**FEMA Levee Certification
Ventura County, California**

**Arroyo Simi Floodwall (AS-7)
South Pacific Railroad Bridge to Stow Street**

**Evaluation Report
February 13, 2009**

TYPICAL EROSION OR SURFICIAL SLOPE INSTABILITY REPAIR

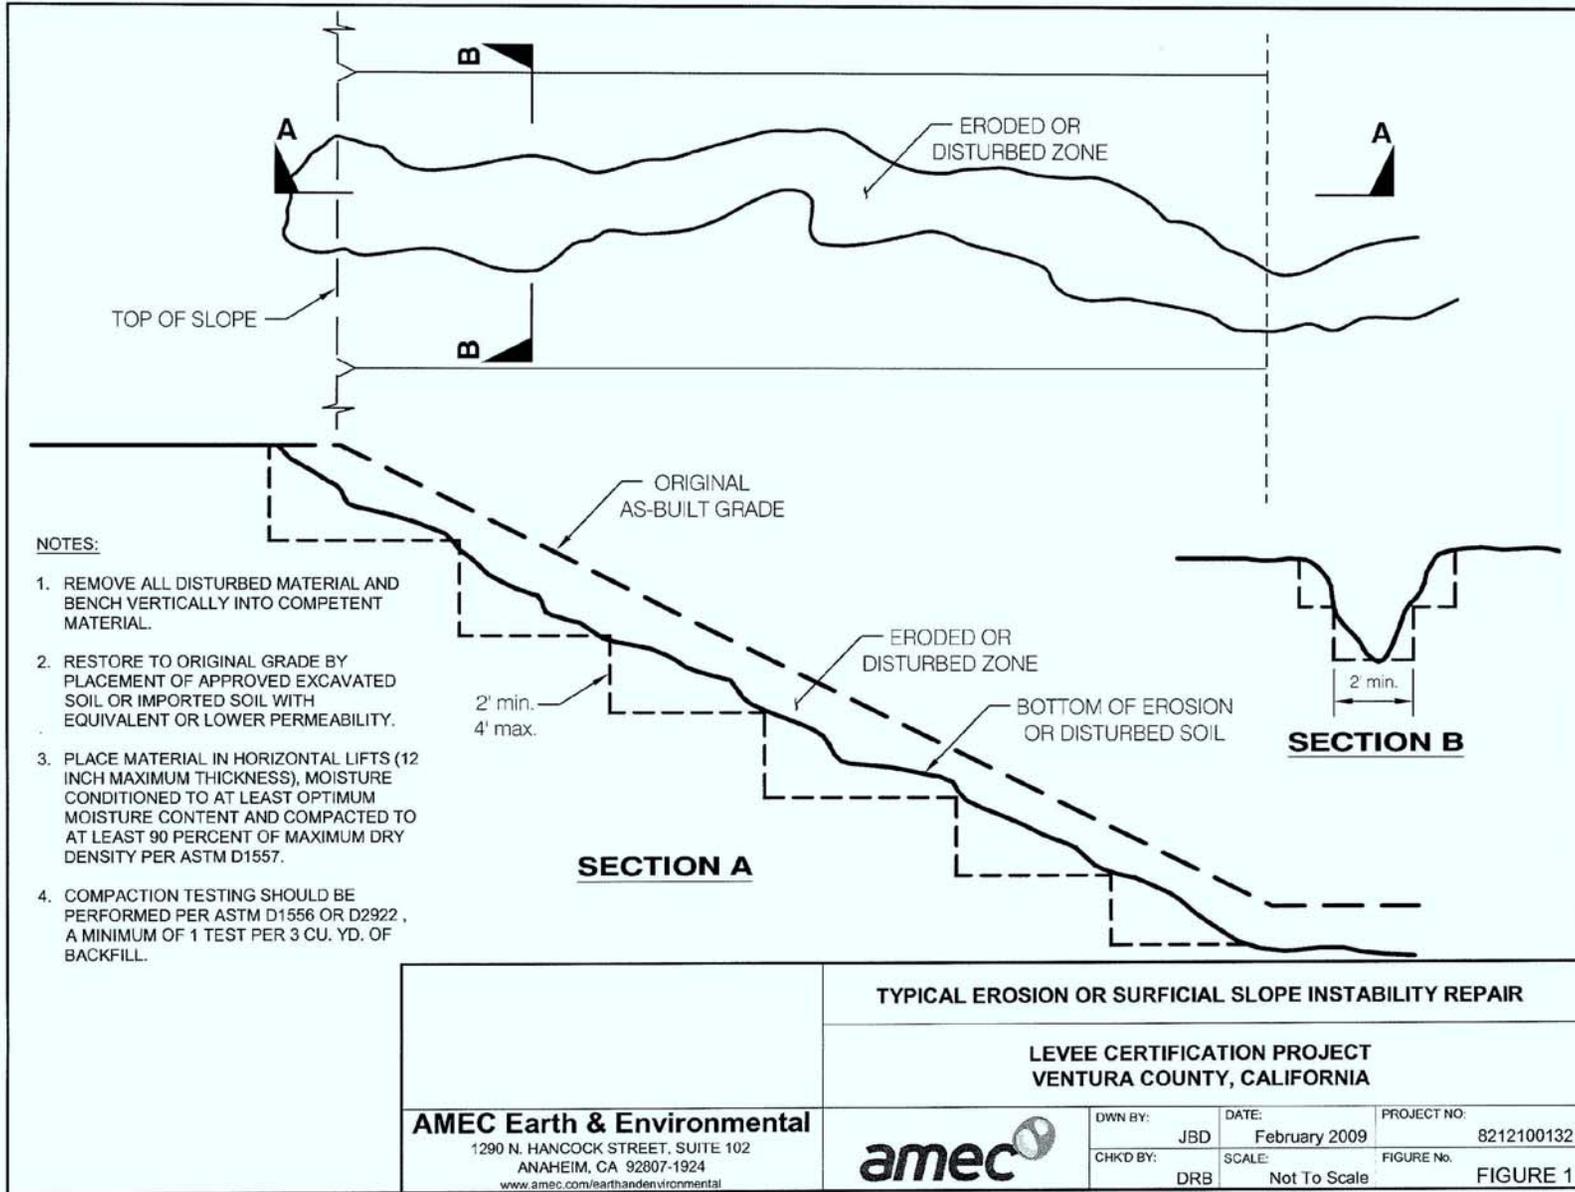
<p>4. Can Tetra Tech provide specs for compaction and grading requirements? Discuss major and minor repair examples.</p>	<p>Compaction requirements are detailed on the attached Figures 1 and 2. Major repair examples include any erosion feature that is deeper than 1 foot or that is greater than 2 feet wide. Major and minor animal burrows are discussed in item 1.</p>
<p>5. Can in-kind materials be used for backfill?</p>	<p>In-kind backfill would be materials free of organic or deleterious debris that has similar or lower permeability than the levee material. These materials could consist of excavated soil, imported soil, concrete, or slurry, and shall be evaluated by the testing and materials lab.</p>
<p>6. Discuss documentation/inspection requirements for verification of grading.</p>	<p>The requirements for verification of grading are discussed above.</p>

1. REMOVE ALL DISTURBED MATERIAL AND BENCH VERTICALLY INTO COMPETENT MATERIAL.
2. RESTORE TO ORIGINAL GRADE BY PLACEMENT OF APPROVED EXCAVATED SOIL OR IMPORTED SOIL WITH EQUIVALENT OR LOWER PERMEABILITY.
3. PLACE MATERIAL IN HORIZONTAL LIFTS (12 INCH MAXIMUM THICKNESS), MOISTURE CONDITIONED TO AT LEAST OPTIMUM MOISTURE CONTENT AND COMPACTED TO AT LEAST 90 PERCENT OF MAXIMUM DRY DENSITY PER ASTM D1557.
4. COMPACTION TESTING SHOULD BE PERFORMED PER ASTM D1556 OR D2922, A MINIMUM OF 1 TEST PER 3 CU. YD. OF BACKFILL.
